INDEPENDENT EXPERT ADVISORY PANEL FOR MINING

**DENDROBIUM COAL MINE
LONGWALL 19A
SUBSIDENCE MANAGEMENT PLAN**

1 August 2023

Figure 2: Location and setting of longwall panels 19 and 19A (Figure 2-1 from HGeo, 2023a).

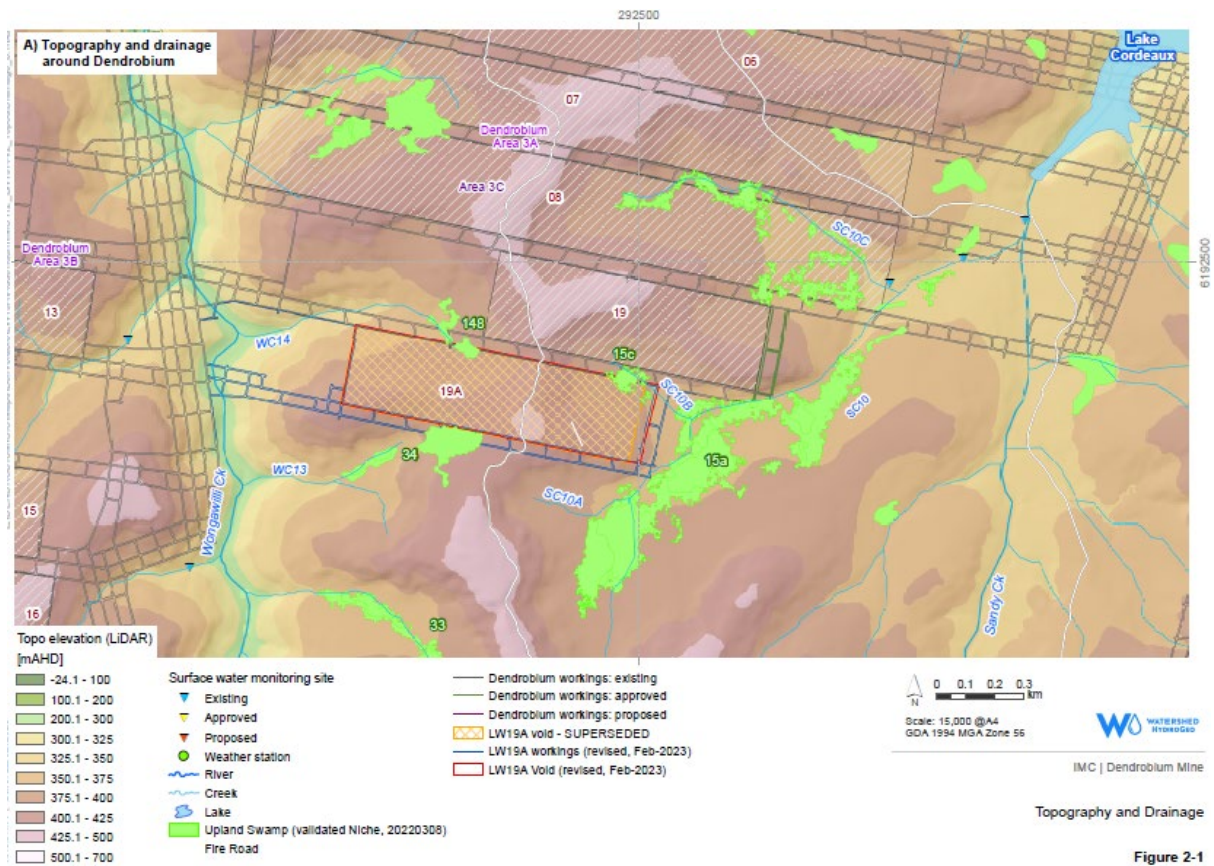
The only swamps closer than 60 m to the proposed footprint of LW19A are Swamps 148, 15c (north) and 34 (south). These overlie the roadways and are immediately adjacent to LW19A (refer Figure 2). They are not the subject of this advice, although the Panel considers it predictable with a high level of certainty that LW19A longwall will result in further ecological changes to these three swamps.

This has caused confusion amongst stakeholders and within the Panel and needs review. The Panel's assessment is based on the Department's advice that at its closest point, Swamp 15a is 61 m from the commencement of LW19A, which appears to be consistent with Figure 2 to Figure 4.

Figure 6: Hydrographs of deep monitoring sensors in VVPs east and west of Swamp 15a (from HGeo, 2023b)

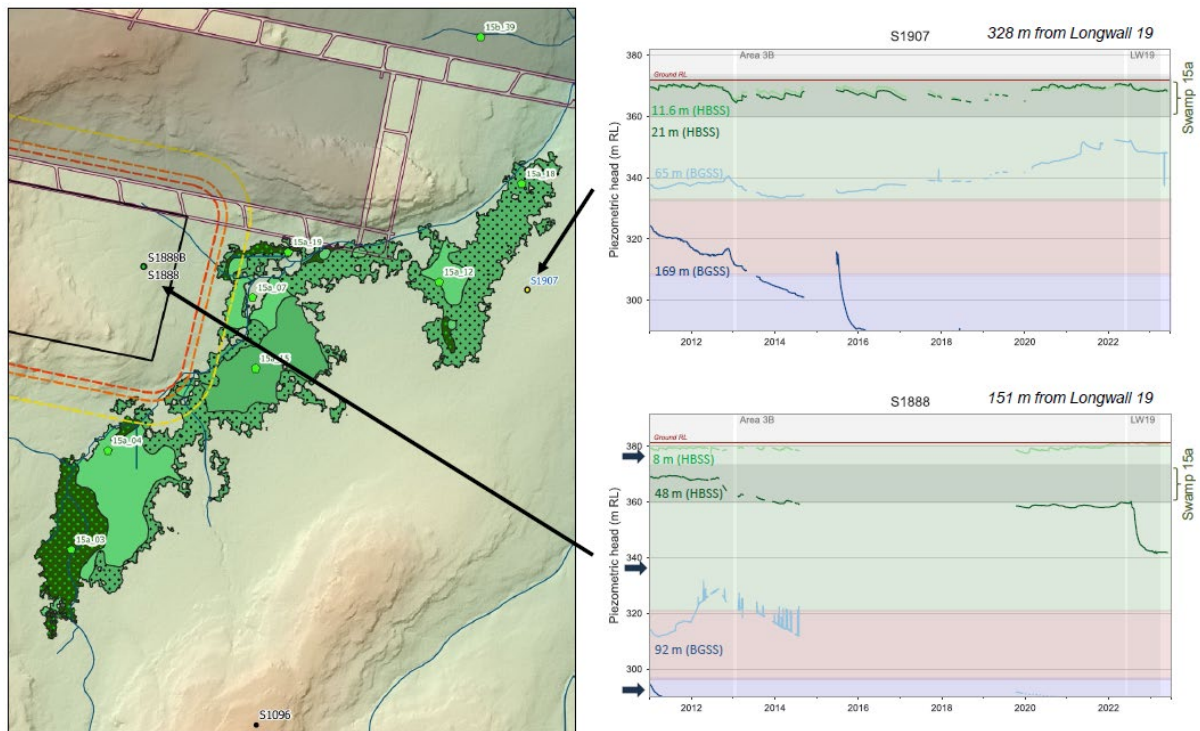
This data suggests a loss of deep groundwater discharge to SC10 and Swamp 15a has already occurred from the western flank of the catchment.

Figure 7: Location of pools and rockbars on SC10 in Study Area (extracted of Drawing No: MSEC1234-09 from MSEC, 2022b).

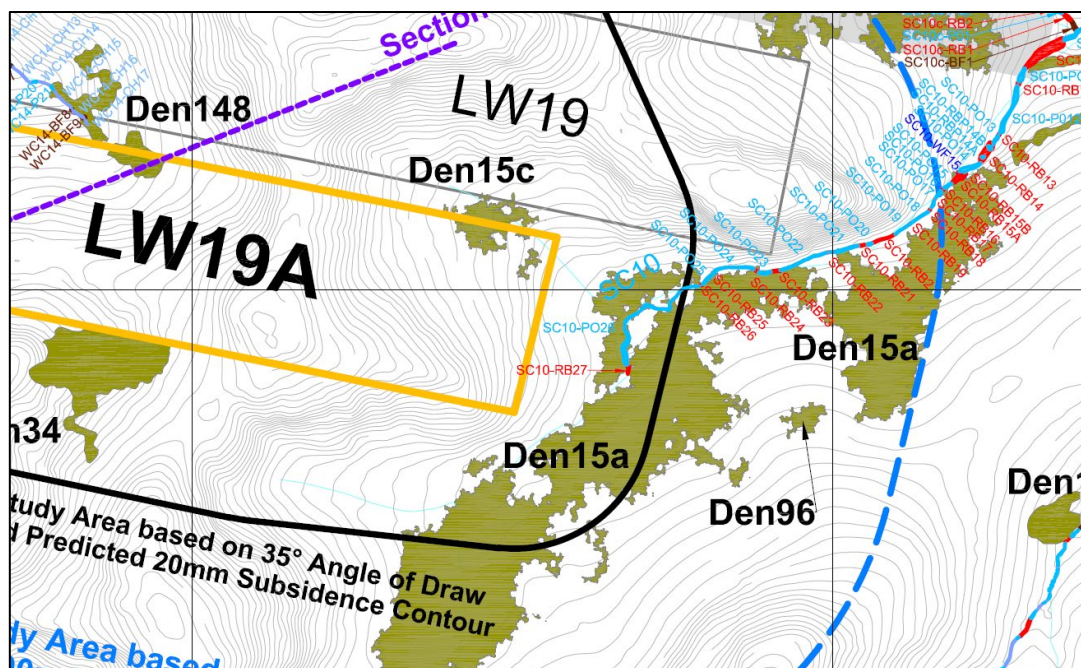
The Consent Condition does not identify the controlling rockbar but Condition 8 – Schedule 3 identifies it as rockbar SC10-RB15a. The subsidence assessment (MSEC, 2022b) does not give any consideration to this rockbar. This is reasonable since, as shown in Figure 7, SC10-RB15a is too remote to fall within the study area for LW19A.

Most of the catchment of SC10B not already undermined by LW19 may lose flow from mining LW19A. Hence, there is potential for loss of flow into Swamp 15a, particularly the long pool SC10-PO26, shown in Figure 7, although it is also possible that the diverted flow will return to the creek prior to reaching this pool. Further, a small loss of baseflow and considerable increase in zero-flow days is predicted in SC10 due to groundwater depressurisation associated with LW19A and cumulative impacts (HGeo, 2022a). This is another potential factor that could have environmental consequences for Swamp 15a.

Figure 7 shows the location of 12 rockbars on SC10 (RB16-27) that are upstream of the main controlling rockbar (RB15A). All these rockbars control SC10 pool water levels and, therefore, potentially control interaction of SC10 flows with the swamp hydrology. Predicted cumulative valley closures up to the completion of LW19 corresponded to low probabilities of Type 3 fractures (*fracturing in rockbar or upstream pool resulting in reduction in standing water level based on current rainfall and surface flow¹⁰*) according to the MSEC rock bar model, being a maximum of 5% at rockbar SC10-RB24. The extraction of the proposed LW19A is predicted to result in incremental closure of up to 50 mm (Table 5.12 of MSEC, 2022b). While this incremental increase may appear relatively small, it is significant because at 10 of the rockbars it results cumulative predicted closure values that are associated with significantly higher likelihoods of Type 3 fractures.¹¹
